REVISE AND
RESUBMIT
HILTON AD&C
10/28/2024

241009 CVGUP Public Area Finish Specs v1.1 (KINETIC) APR 2024_Revise and Resubmit_28OCT24.pdf Markup Summary

Hampton by Hilton - Public Area Finish Specifications - Kinetic (B)

CVGUP CINCINNATI / UPTOWN - UNIVERSITY AREA

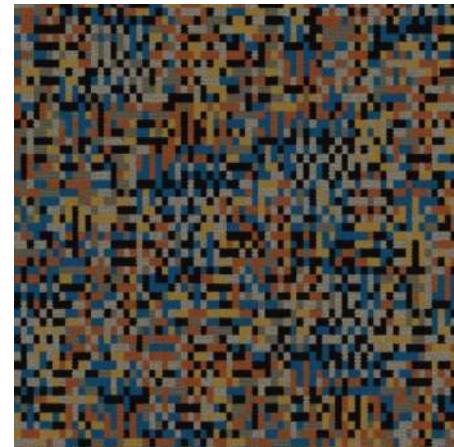
Revise all area rugs to meet brand standard requirements

- 2514.03.H.1.a
- 2514.03.H.9

We are taking the prototype broadloom carpet and will bind it and add pad on back. We do not want to make this custom item as it will have to be if we have make it a true rug.
